**Addendum No. 3**  
**To**  
**INVITATION FOR BIDS NO. DCAM-19-CS-IFB-0011**  
**ROOF REPLACEMENT AND MASONRY RESTORATION AT**  
**1131 SPRING ROAD NW**

**Issued: July 3, 2019**

# Exhibit 1

Sheet No.  
**D-1**

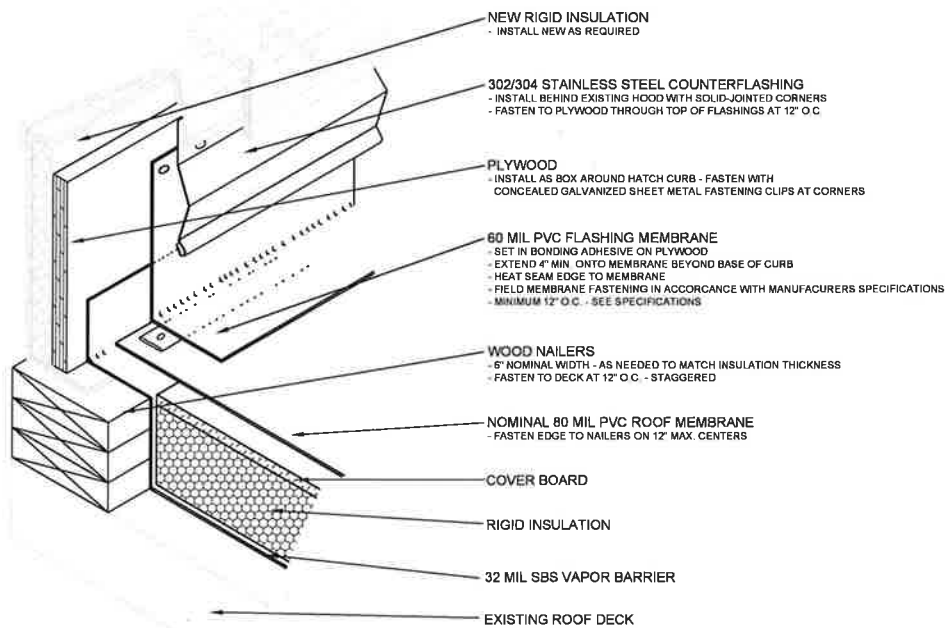
13. We noticed the HVAC system was not flashed to the roof, is there a reason for this?	Please use the attached Addendum # 1 Detail D-1 – HVAC ROOF CURB for securement of the existing HVAC roof curb.

14. Once the HVAC system is reinstalled on the roof, does DGS require that we install flashing?	Yes.
15. Who is responsible for the permits?	Contractor
16. What are the work hours?	M-F 7:30am – 7:00pm (Contractor can arrive onsite at 7:30am, but no use of tools or equipment until 8:00am. Contractor must be packed up and offsite by 7pm.).

- Note:
1. Lift existing roof curb to accommodate new wood blocking as shown in detail.
  2. Fasten new wood blocking as specified
  3. Fasten existing roof curb to the new wood blocking set to the height of the new R=25.00 insulation.
  4. Install new insulation to the roof curb walls and fasten new plywood as shown in the detail.
